HOMEPORT ACRES SUBDIVISION, FIRST ADDITION

APPLICATION NUMBER 21 DATE April 7, 2005
APPLICANT Homeport Acres Subdivision, First Addition
REQUEST Subdivision

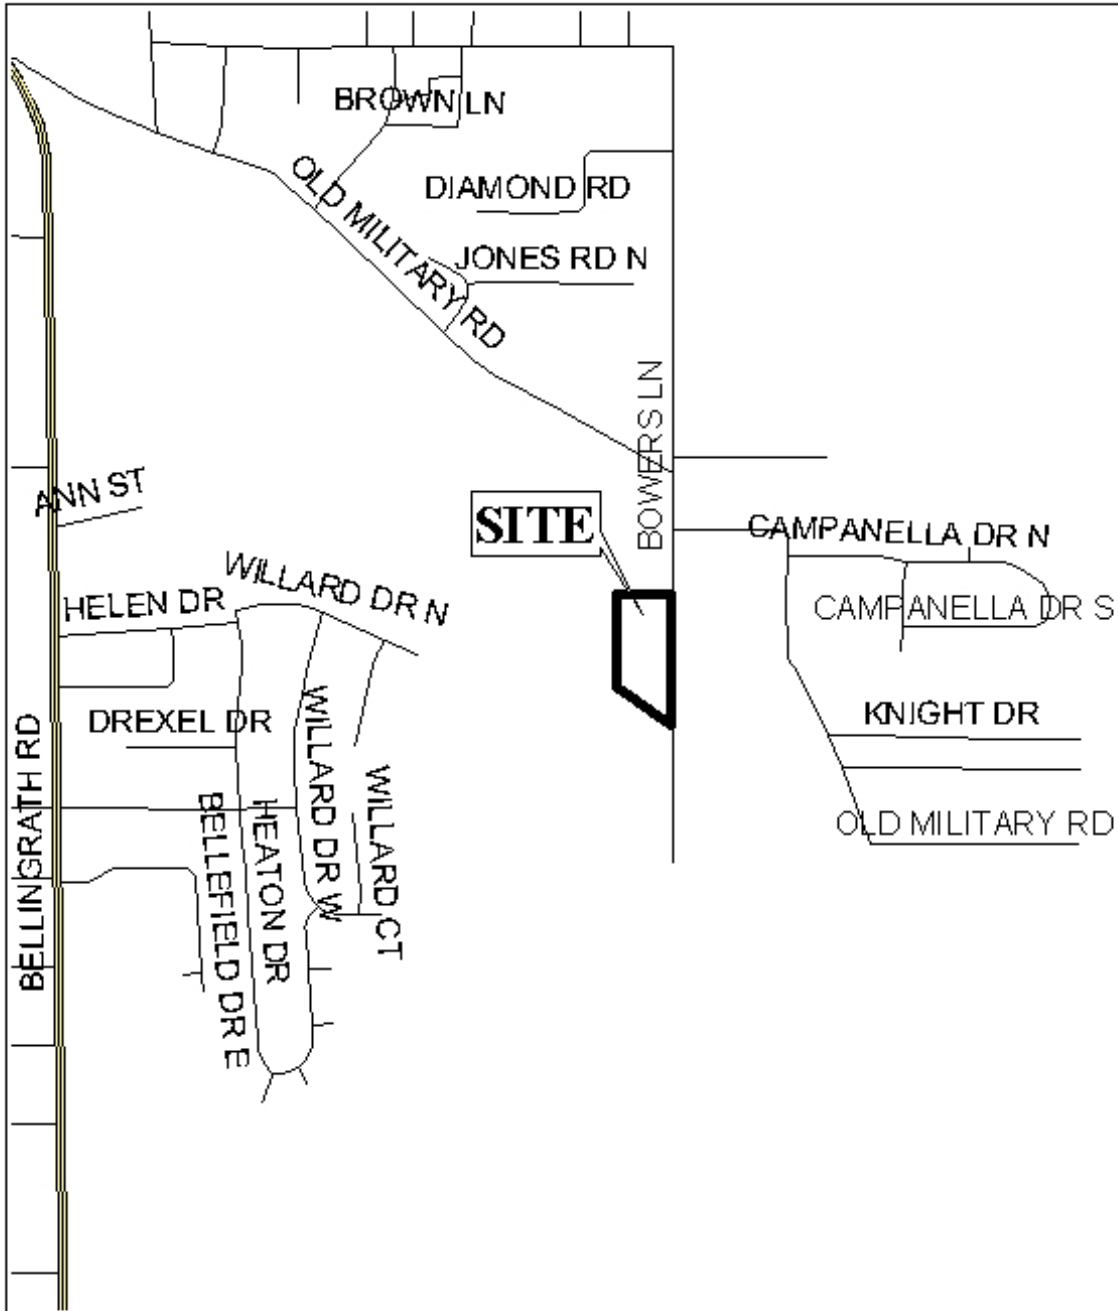
Bowers Lane is a minor street with a 50-foot right-of-way, and the minimum right-of-way width for a minor street lacking curb and gutter, such as Bowers Lane, is 60 feet, or 30 feet in each direction as measured from the centerline of the roadway. Since the existing right-of-way does not meet the recommended minimum width for a minor street lacking curb and gutter, according to Section V.B.14. of the Subdivision Regulations, the dedication of an additional 5 feet of right-of-way should be required. Additionally, the 25-foot minimum building setback line depicted on the plat should be adjusted to reflect the recommended right-of-way dedication.

Bowers Lane is paved to approximately the southern lot line of the proposed lot 5, and is unpaved from that point south to its termination south of Muddy Creek. The proposed lot 6, therefore, appears to have limited, if any, access to the paved portion of Bowers Lane. It is recommended that lot 6 be provided with a minimum of 25 feet of frontage onto the paved portion of Bowers Lane, and that further subdivision of lot 6 be restricted until the unpaved portion of Bowers Lane is improved to Mobile County paved street standards.

The depth to width ratio for lots 1 through 5 is approximately 4.4 (depth is 4.4 times the width), which is greater than the 3.5 recommended in Section V.D.3. of the Subdivision Regulations. Other parcels in the area reflect similar width to depth ratios slightly greater than recommended in Section V.D.3., thus a waiver of Section V.D.3. could be considered appropriate.

The southern portion of the site is bounded by Muddy Creek, and wetlands associated with the creek may occur on a portion of the site. The site, additionally, appears to be partially located in the “floodway” and “100-year” frequency flood zone as depicted on FEMA maps, and thus may be subject to flooding. The presence of wetlands and floodplains indicate that the area may be environmentally sensitive; therefore, the approval of all applicable federal, state and local agencies would be required prior to the issuance of any permits.

With a waiver of section V.D.3., the plat is recommended for Tentative Approval, subject to the following conditions: 1) the dedication of 5 feet of right-of-way along Bowers Lane, in accordance with Section V.B.14.; 2) that Lot 6 have a minimum of 25-feet of frontage on the

paved portion of Bowers Lane, and placement of a note on the Final Plat stating that further subdivision of Lot 6 is prohibited until the remainder of Bowers Lane adjacent to Lot 6 is improved to Mobile County standards for paved streets; 3) the placement of a note on the Final Plat stating that any lots which are developed commercially and adjoin residentially developed property must provide a buffer, in compliance with Section V.A.7. of the Subdivision Regulations; and 4) the approval of all applicable federal, state and local agencies regarding the wetlands and floodplain issues.
